Specifications for Manhole and Duct Structure Facilities

Specification MMD - 5
Revision 1, February 2005

SUMMARY OF SIGNIFICANT changes in MMD-5 DATED February 2005
PAGE 1 OF 2

TYPICAL DUCT SECTION

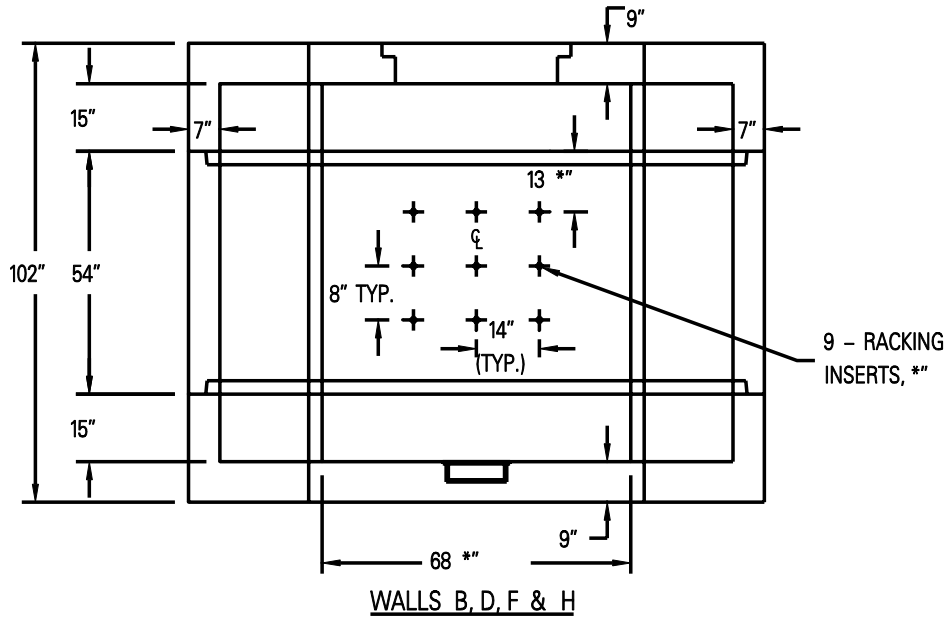
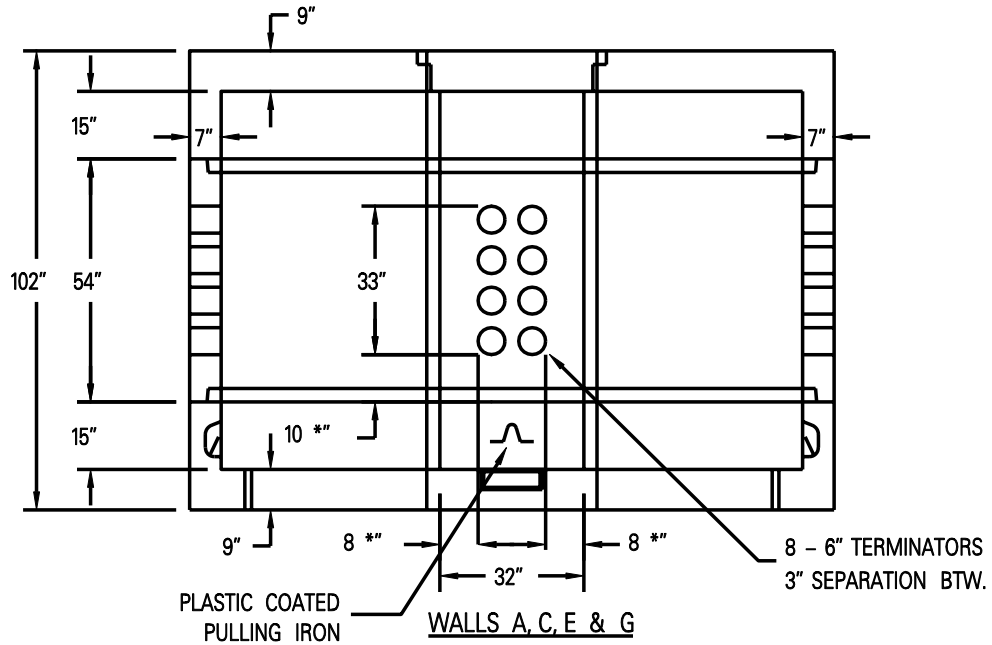
PAGE 12 – TYPICAL DUCT SECTION

Revised to indicate minimum of 30 inches backfill over concrete encased duct.

4 WAY MANHOLE

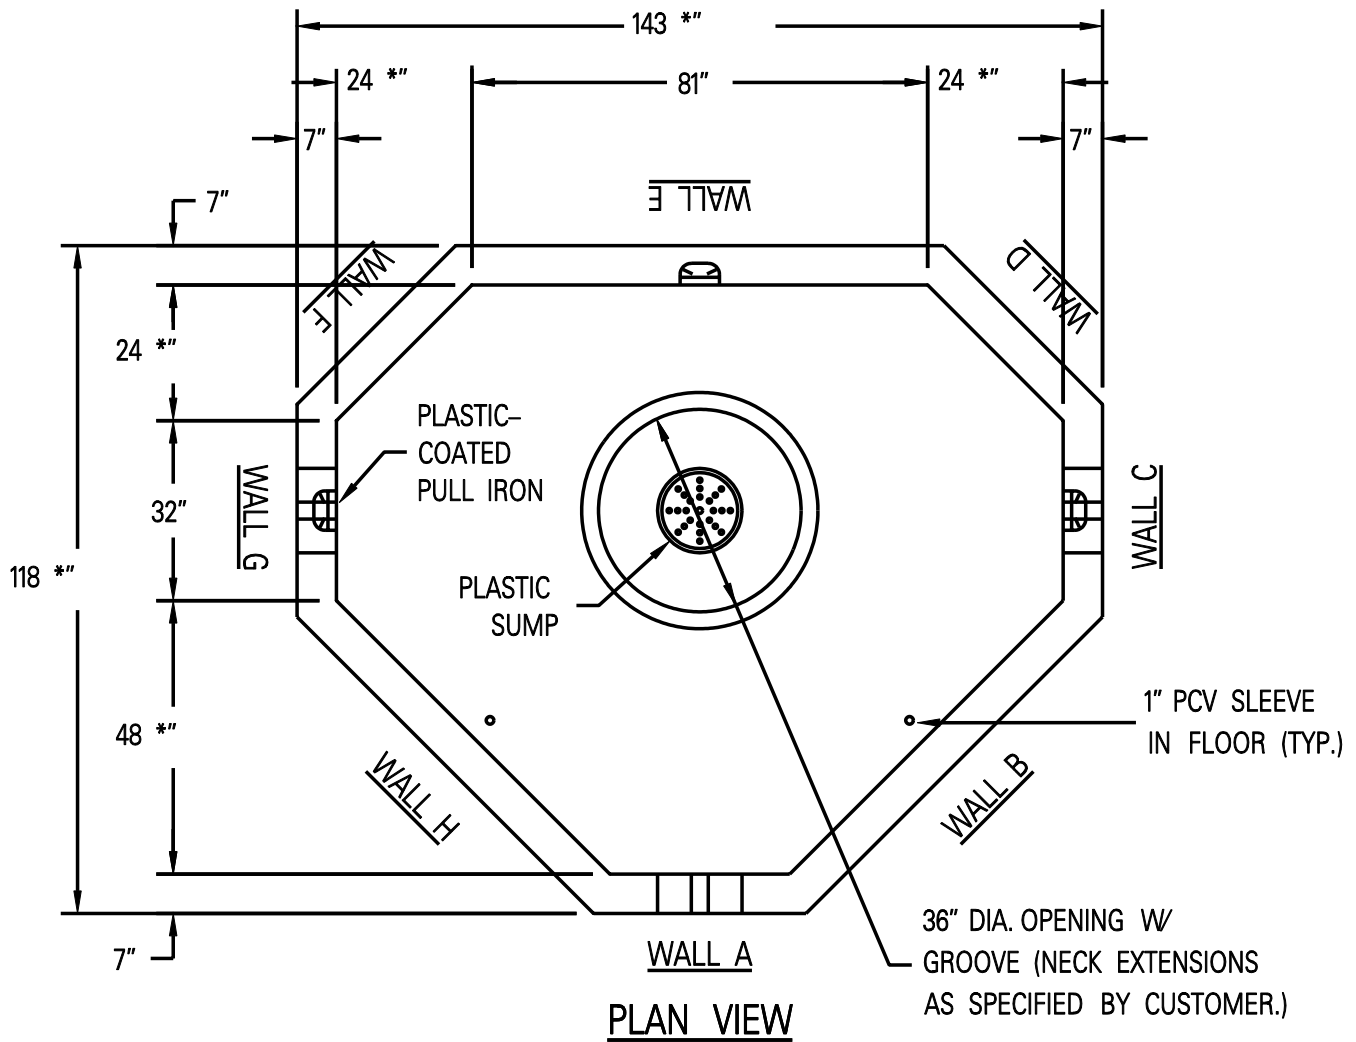
PAGE 14 – 4 WAY MANHOLE

Revised to indicate that the typical spacing of the Racking Inserts is 8 inches on center. (It was 12 inches on center per the previous MMD-5.)

MANHOLE NECK

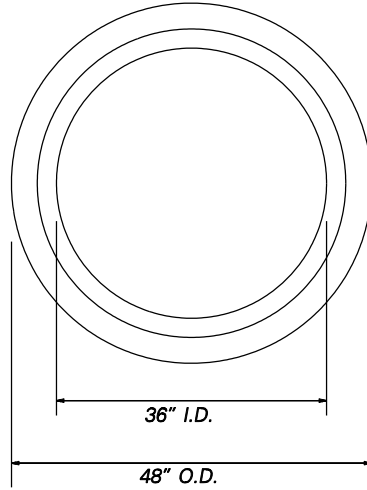
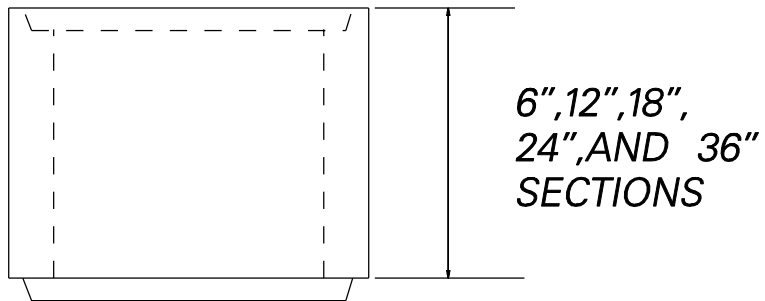
PAGE 18 – MANHOLE NECK

Revised to indicate the Manhole Neck extensions are as follows:
Namely: 6, 12, 18, 24 and 36 inches

TERMINATION OF CONDUIT LINE FOR FUTURE USE

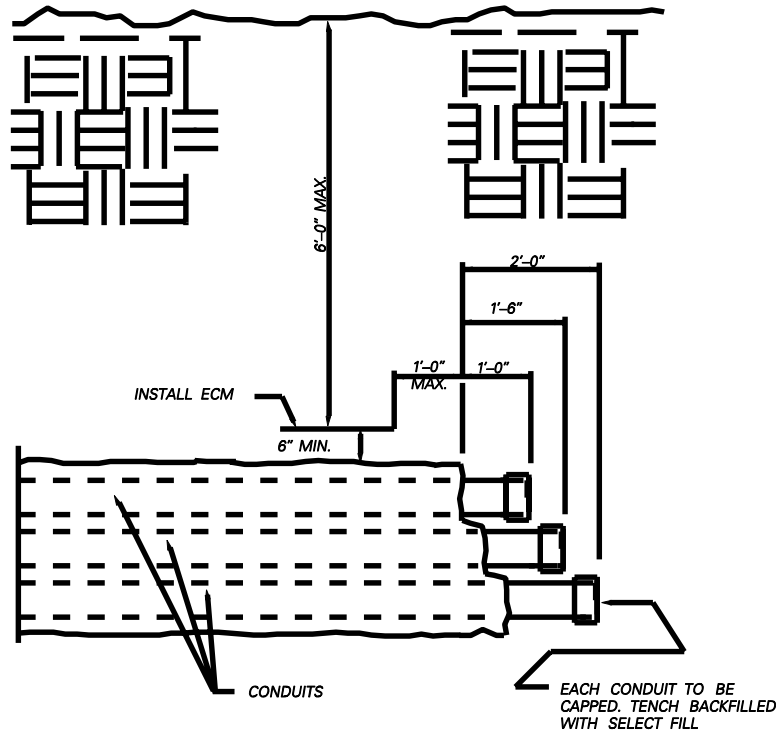
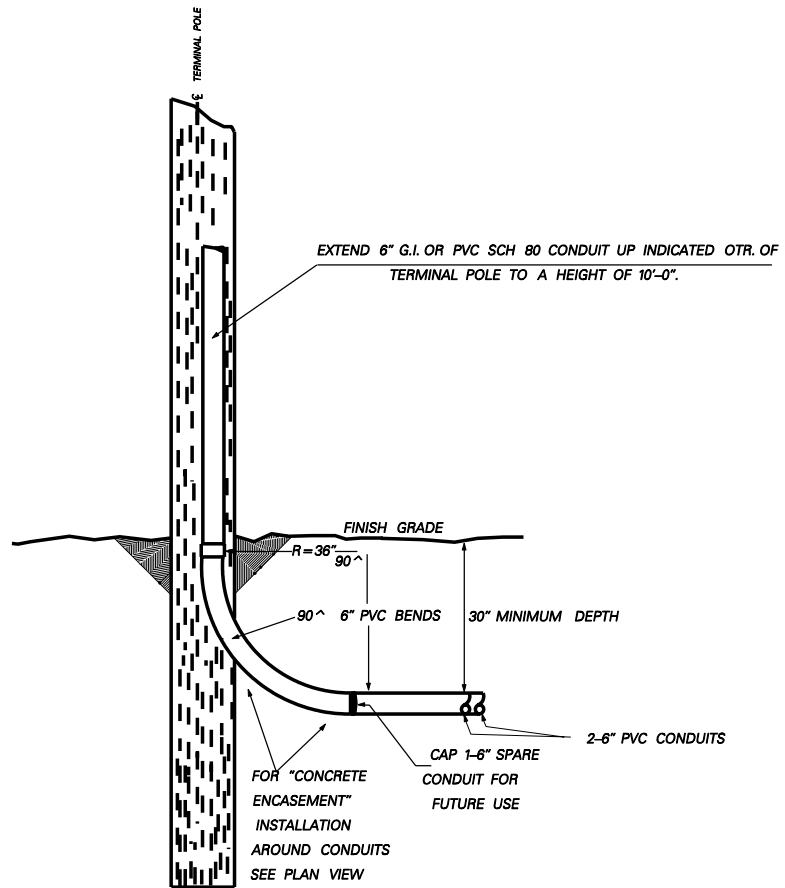
PAGE 20 – TERMINATION OF CONDUIT LINE FOR FUTURE USE

Revised to clarify the dowelling. Added sentence to the INCOMPLETE DUCT LINE Item 2. “Install #5 dowel with 8 inches minimum embedment.

1. ON ALL INCOMPLETE DUCT LINES (DUCTS THAT ARE TO BE EXTENDED AT A FUTURE TIME). THE CONDUITS ARE TO BE WATERTIGHT WITH A CONDUIT CAP SOLVENT CEMENTED INTO PALCE.
2. DOWELLING IS THE METHOD TO BE USED IN ORDER TO JOIN NEW DUCT TO EXISTING UNFINISHED DUCT. INSTALL #5 DOWELL WITH 8 INCHES MINIMUM EMBEDMENT.

TERMINATION OF CONDUIT AT RISER POLE

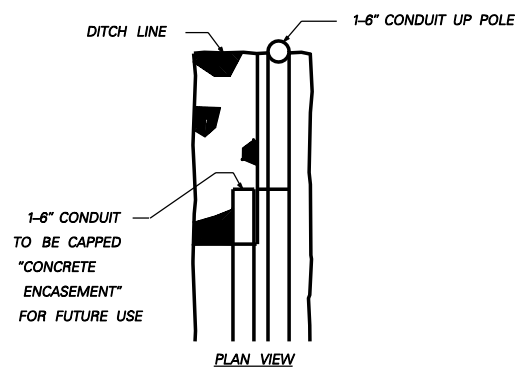
PAGE 20 – TERMINATION OF CONDUIT AT RISER POLE

Revised to indicate that all underground conduit and bends shall be PVC. The use of GI is limited to above grade and UP THE POLE only.

SWITCHGEAR PAD DETAIL

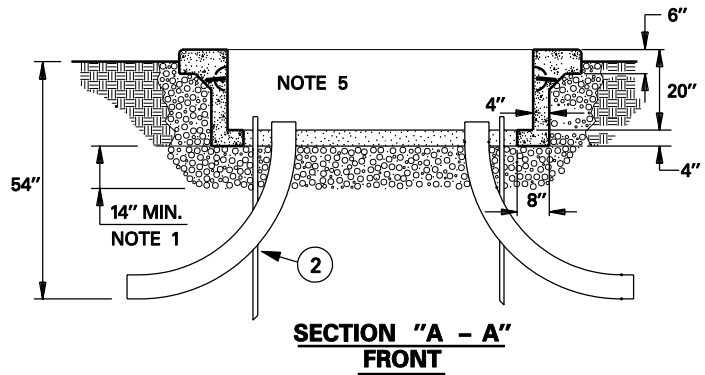
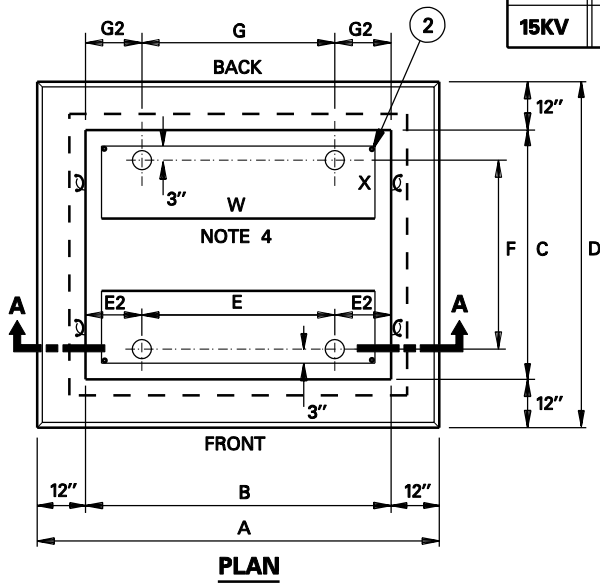
PAGE 23 – SWITCHGEAR PAD DETAIL

Completely replaced this drawing with most current deep well drawing.

MANHOLE FRAME & COVER

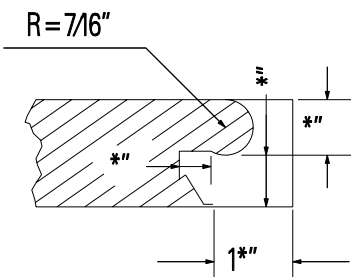
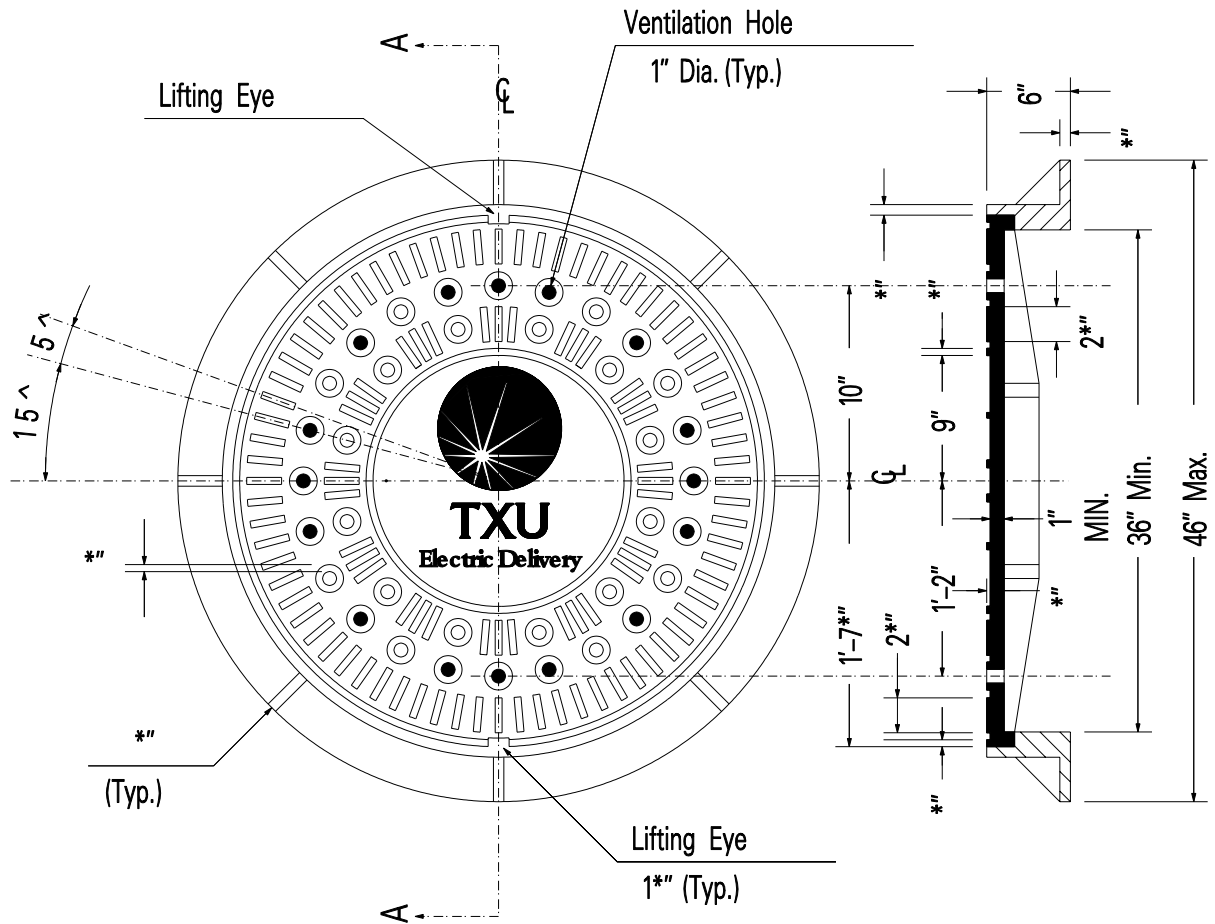
PAGE 24 – MANHOLE FRAME AND COVER

Revised to latest Company drawing with TXU Electric Delivery Logo.
